TABLE C
 RESOLUTION SUMMARY of JUNE 3, 2019 CATE STREET EXTENSION TRAFFIC STUDY - MIXED USE PROPOSAL
 TRANSPORTATION PEER REVIEW #2

RE: Response to Cate Street Extension Peer Review Comments, June 3, 2019
Response to Cate Street Extension Traffic Study - Peer Review Comments, June 3, 2019

Response to Cate Street Extension Peer Review Comments, June 3, 2019

Surrounding Neighborhood and Roads:

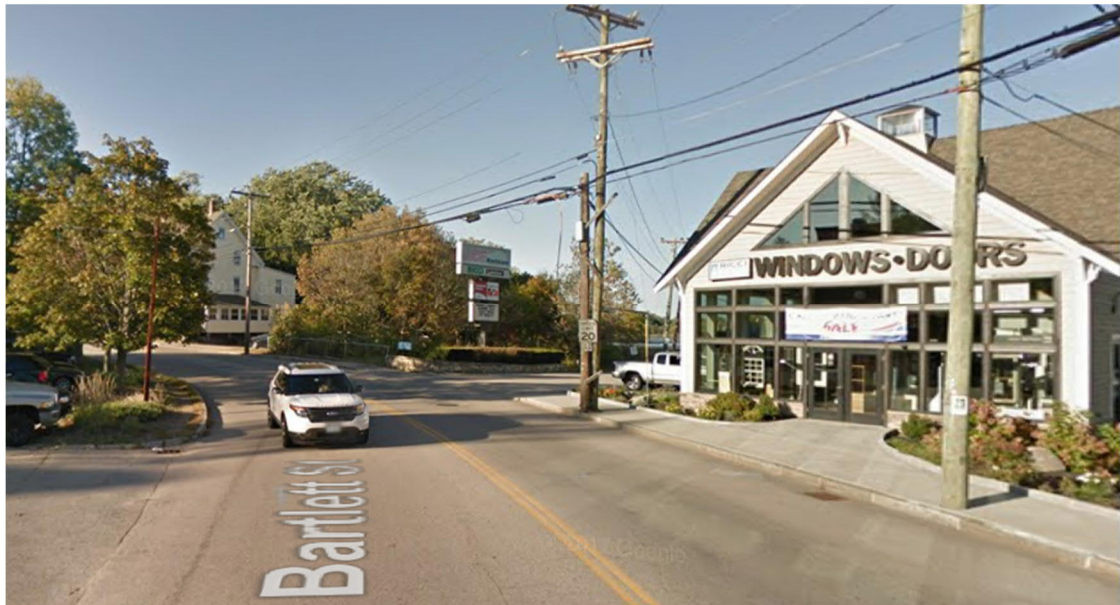
The surrounding neighborhood and street network, its posted speed limits and typical traffic is also of a concern since these roads are quieter and in the case of Woodbury Avenue and Bartlett Street have sections with posted design speeds of 20 mph in close proximity to the Bartlett Street Cate Street intersection.

The traffic from Cate Street will be encountering drivers on Bartlett and Islington Streets that will be travelling at slower speeds. These drivers will have been travelling at these slower speeds for some time when they reach the Cate Street Bartlett Street intersection. Drivers turning north onto Bartlett Street from Cate Street will need to be travelling at 20 mph immediately.

Railroad Overpass and Approach Curve to Islington Street:

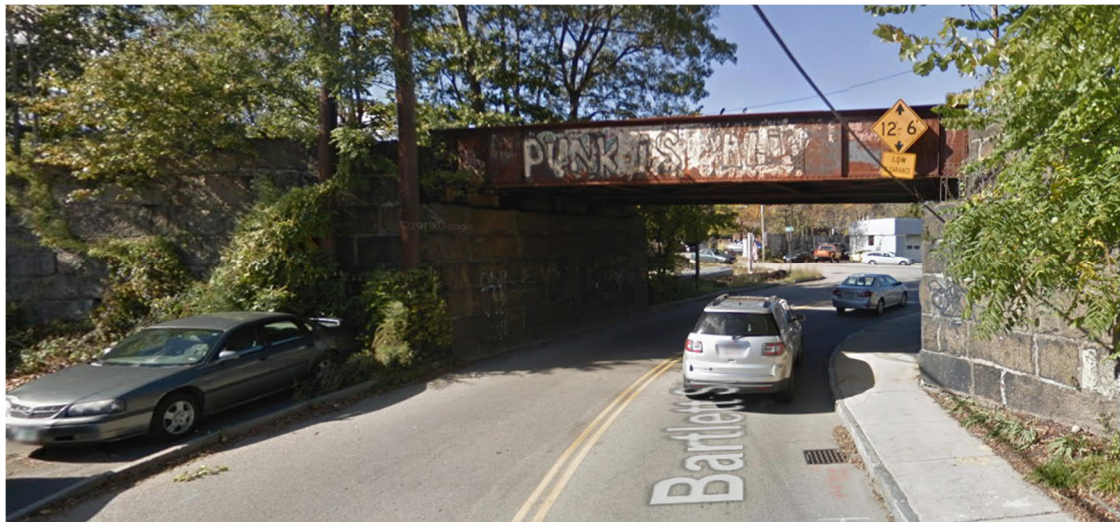
The final curve on Cate Street that approaches the Railroad Overpass before Islington Street to the southeast is 110-ft. This curve cannot be posted for speeds above 20 mph. Further it would be unsafe in our opinion to do so due to the narrow opening of the overpass and the imposing construction.

The photos on the following page illustrate both the limitations created height and width wise by the overpass and, in the second photo, the proximity to Cate Street which will be re-aligned to curve into the overpass.

Drivers coming from the intersection at Islington north through the overpass to Cate Street and Bartlett Street will have limited sight distance. Increased design speeds headed to this intersection will exacerbate the situation for these drivers further impacting decision time for them as they judge turning onto Cate Street and or Bartlett Street.

The Low clearance at this location will limit truck traffic as well. Trucks will need to turn north onto Bartlett Street from Cate Street. Large trucks will not be able to clear the overpass due to height.

| <p>335-FT REVERSE CURVES NO TANGENT POSSIBLE</p> | | | |

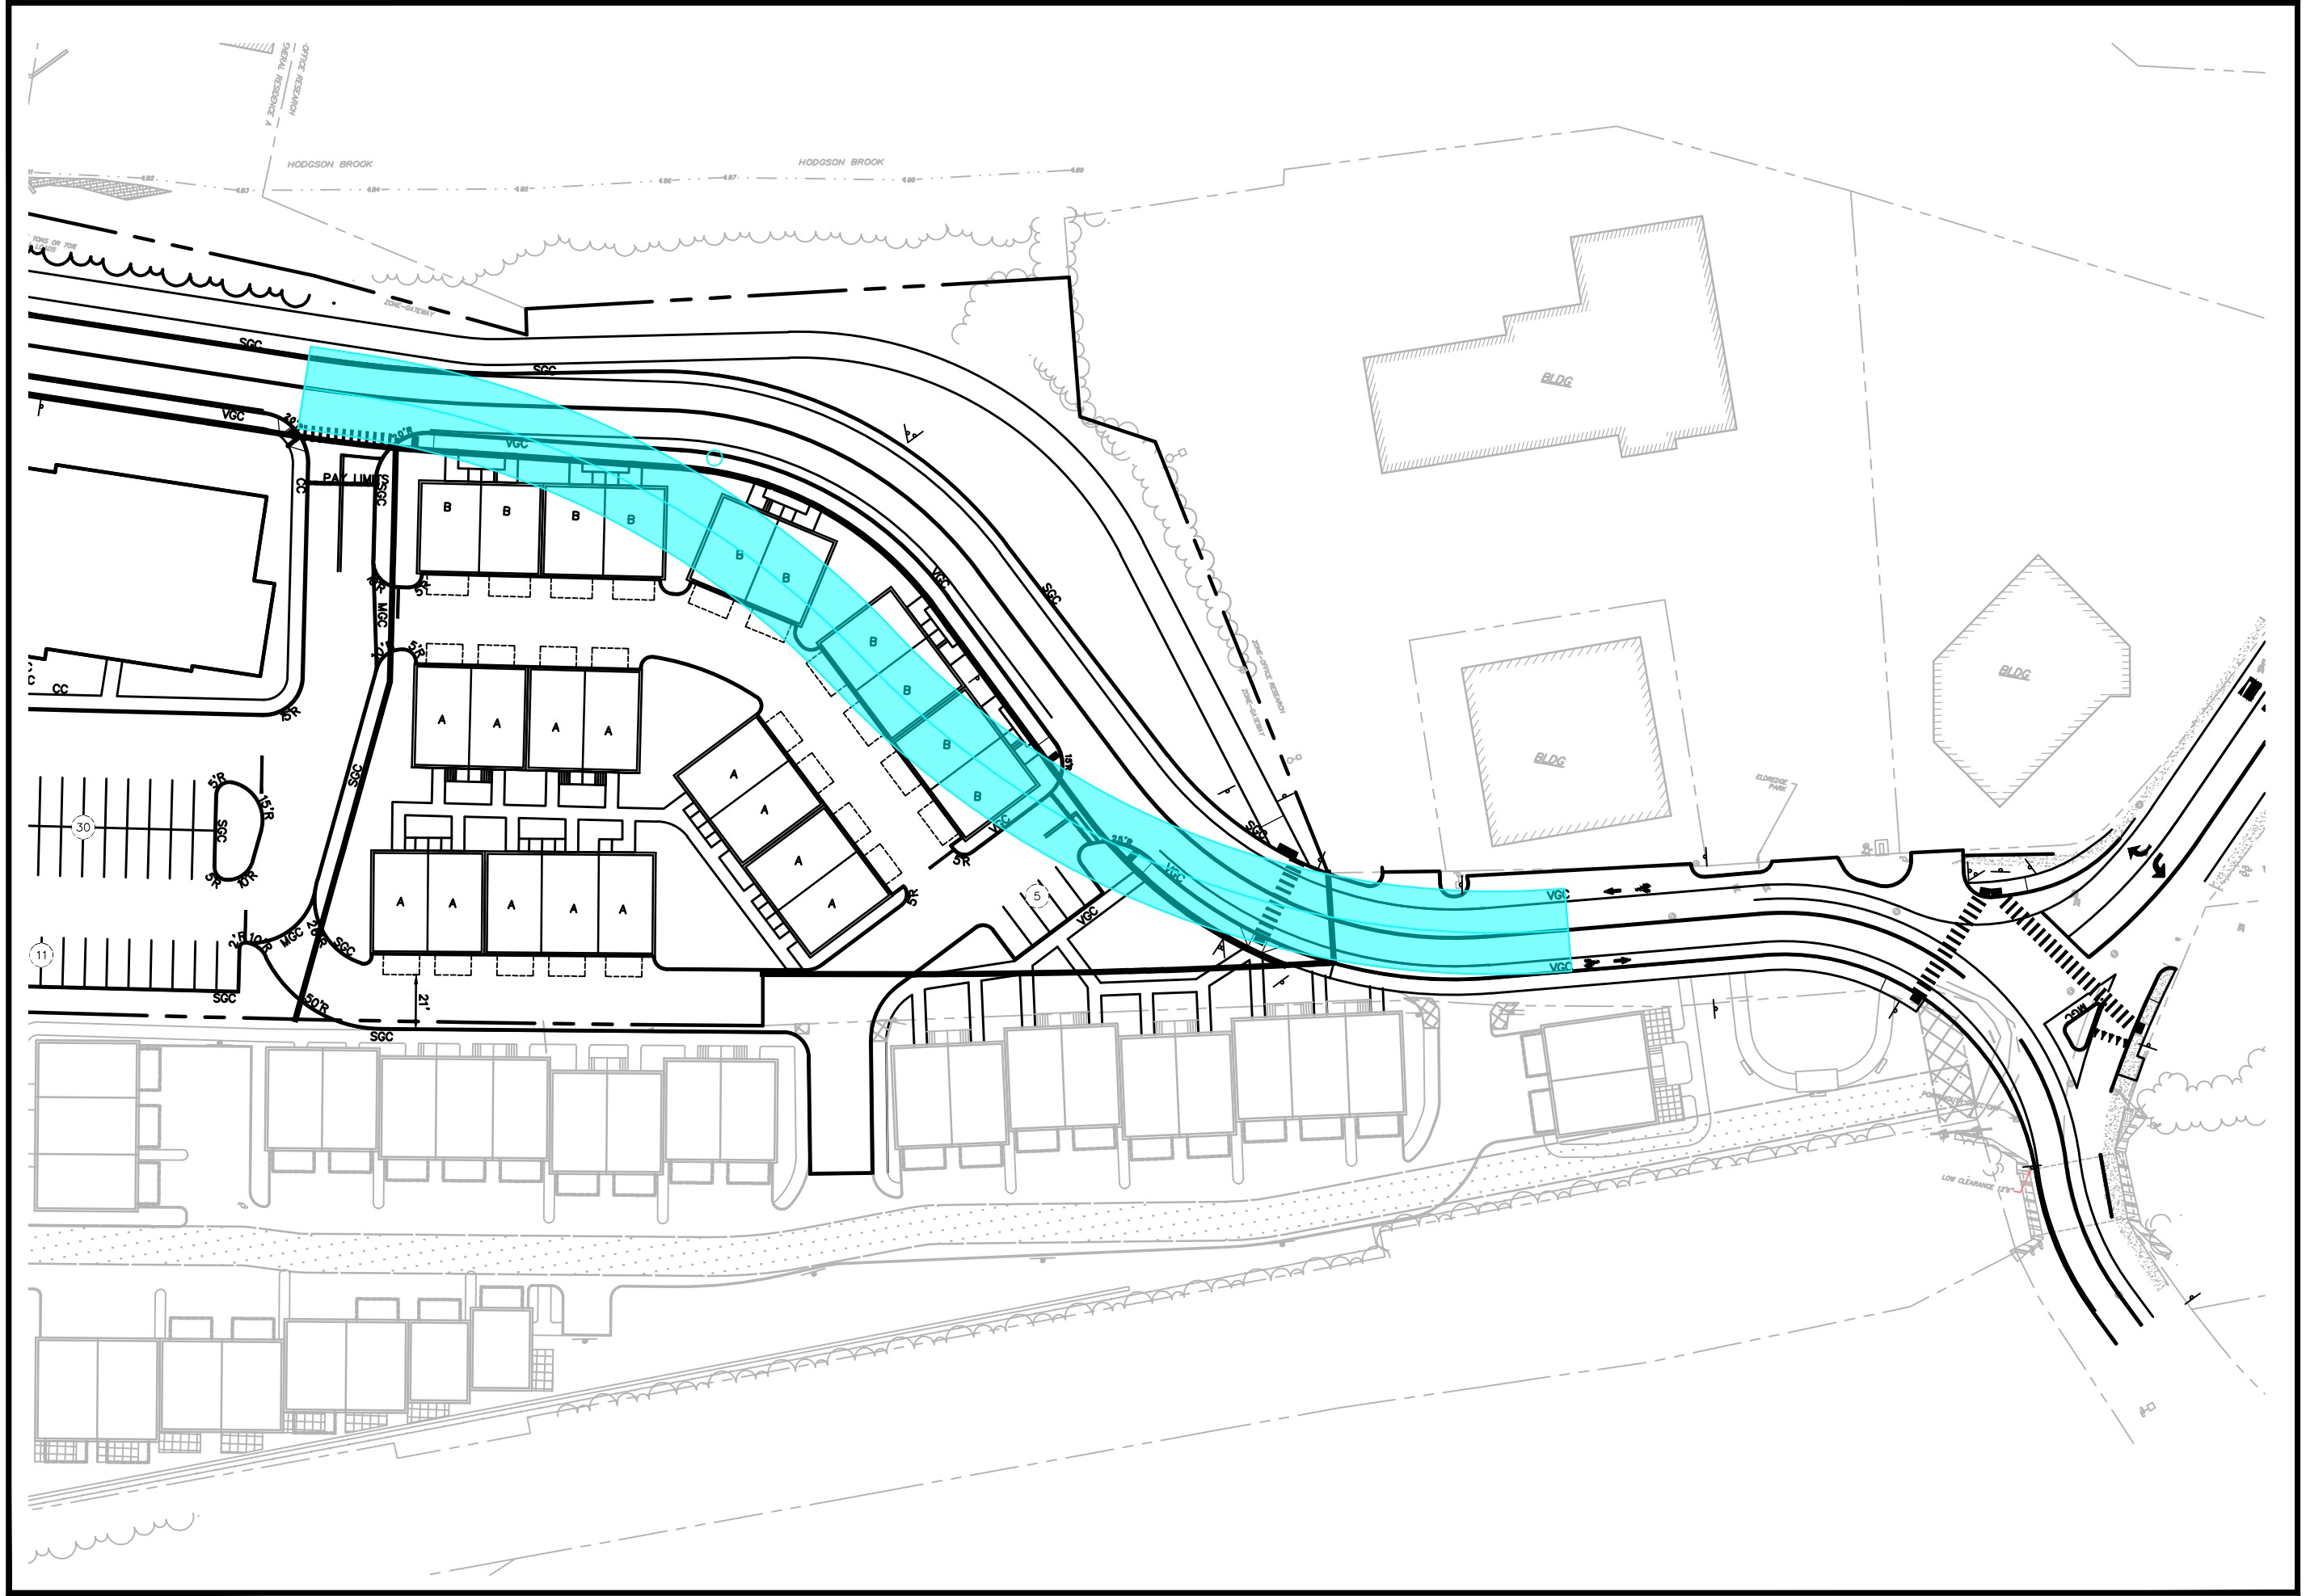
- 1. The City classifies Cate Street / Cate Street Extension as a Neighborhood Connector, per the City of Portsmouth Complete Streets Design Guidelines, dated June 2017. Accordingly, the design speed for this roadway should be 30 mph. To the maximum extent practical, all design criteria should meet a design speed of 30 mph, or adequate justification shall be provided for specific elements not meeting this design speed, for consideration by the City.*

The radius cited per AASHTO Table 3.7 is applicable for a roadway that is superelevated at 4.0%; however, the typical roadway sections and grading plans show that the roadway is crowned at 2.0%. AASHTO Table 3.13 indicates the minimum radii for various cross slopes, including normal crown (-2.0%).

Larger radii reverse curves were explored. See exhibits attached to this letter.

Brayerston Condominiums reduces the curve radius while marginally increasing the possible curve that will fit as one travels west toward Route 1 Bypass into the site. However, a larger curve entering the Development site west of the Cate Street Bartlett Street intersection will shorten the tangent approaching the curve in the intersection. Currently the Tangent between curves is 106-ft long. Shortening this tangent is not advised. Typically a minimum tangent between reverse curves of 100-ft is advised for low speed roads. Tangents help the driver transition between curves and direction changes.

Mr. Eby agreed that eliminating the tangents was not a satisfactory design outcome. He echoed our concerns that it limits driver's ability to transition between curves and direction changes.
